### 5609

USE, PARKING SURFACING, AND ACCESS AND MANEUVERING VARIANCES TO ALLOW AN ATTORNEY'S OFFICE IN AN R-1, SINGLE-FAMILY RESIDENTIAL DISTRICT, WITH AGGREGATE SURFACING, AND MANEUVERING AREA OF 12 FEET; THE ZONING ORDINANCE REQUIRES A MINIMUM R-B, RESIDENTIAL-BUSINESS DISTRICT ZONING, PARKING SURFACES PAVED WITH ASPHALT, CONCRETE, ASPHALTIC CONCRETE, OR AN APPROVED ALTERNATIVE SURFACE, AND 24-FEET OF ACCESS AND MANEUVERING AREA.

#### 215 SOUTH CEDAR STREET

BOARD OF ZONING ADJUSTMENT
APRIL 2010

## BOARD OF ADJUSTMENT VICINITY MAP - EXISTING ZONING

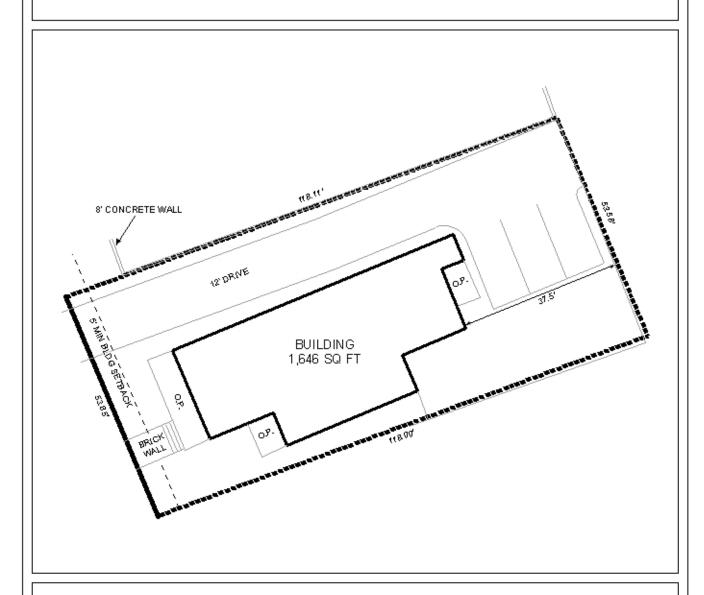
impracticable. Entry into the parking stalls would be severely restricted as proposed on the site plan, and exiting from the last two stalls would be restricted. However, with a revision of the parking stalls to be located further to the South, more maneuvering area could be achieved for vehicles both entering and exiting the stalls. This should be coordinated with Traffic Engineering.

The applicant has illustrated that use of the property for an attorney's office would be consistent with its use for the past 19 years and the Board should consider the Use Variance for approval, subject to conditions. The Parking Surface Variance should also be considered for approval, especially in light of the Architectural Review Board's approval of such and the residential character it imparts. The applicant has illustrated that a literal enforcement of the Ordinance would result in an unnecessary hardship with respect to the substandard driveway access to the proposed rear parking area. However, the access/maneuvering area hardship associated with the parking stalls entry and exit could be relieved by the revision of the site plan to place the stalls further to the South.

The Access/Maneuvering Variance request is recommended for approval with the modification of the site plan to relocate the parking stalls to the South to provide as much access/maneuvering area as practicable, subject to the following conditions:

- 1) coordination with Traffic Engineering on the revised location of the parking stalls; and
- 2) submission of a revised site plan to the Planning Section reflecting all approval conditions prior to the obtaining of any permits.
